SUBJECT: VIRGIL C. SUMMER NUCLEAR STATION, UNIT 1 – ALTERNATIVE REQUEST  
REGARDING SNUBBERS (TAC NO. MF5775)

SAFETY EVALUATION BY THE OFFICE OF NUCLEAR REACTOR REGULATION

FOURTH TEN-YEAR INSERVICE INSPECTION PROGRAM INTERVAL

VIRGIL C. SUMMER NUCLEAR STATION, UNIT 1

Figure 1

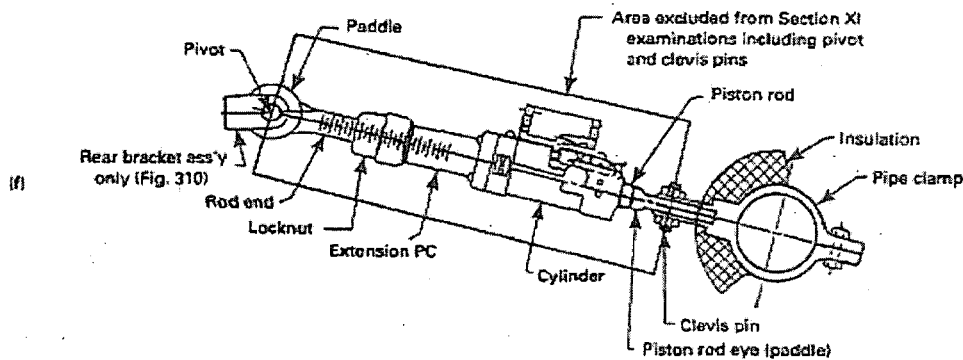
The 2007 Edition through the 2008 Addenda of ASME Section XI contains Figure IWF-1300-1(f), which depicts the examination boundaries for snubber (as shown in Figure 1 below).

The component supports include (1) snubbers; and (2) their attachment hardware (pin-to-pipe and pin-to-structure). The examination and inspection of the snubbers (pin-to-pin) are to be performed per Subsections ISTA and ISTD of the ASME OM Code. Whereas, supports attachments hardware pin-to-pipe and pin-to-structure are to be performed as specified in paragraphs IWF-1220 and IWF-2000 of the ASME Section XI. The licensee states that having two similar sets of requirements for the visual examination and inspection for the same component supports: one for snubbers and another for their attachments and hardware, would require the performance of redundant examinations and cause unnecessary confusion in sample selection, data collection and documentation of these examinations.

- (1) The ASME Section XI, 2007 Edition including the 2008 Addenda, Figure IWF-1300-1(f) specify boundaries between snubber (pin-to-pin) and its attachments. Based on Figure IWF-1300-1(f), the snubber (pin-to-pin) inservice examination and testing requirements are provided in the ASME OM Code, whereas snubber' attachments inservice examination requirements are provided in the ASME Section XI. The Relief Request No. RR-4-08 proposes to perform the visual examination of snubbers and associated attachment hardware (pin-to-pipe and pin-to-structure, excluding integral attachments) along with snubber (pin-to-pin) visual examination in the Snubber Program.

Based on the above, the NRC staff finds that the licensee proposed alternative of snubber boundaries for visual examination, which includes snubbers and their attachments, provides an acceptable level of quality and safety.
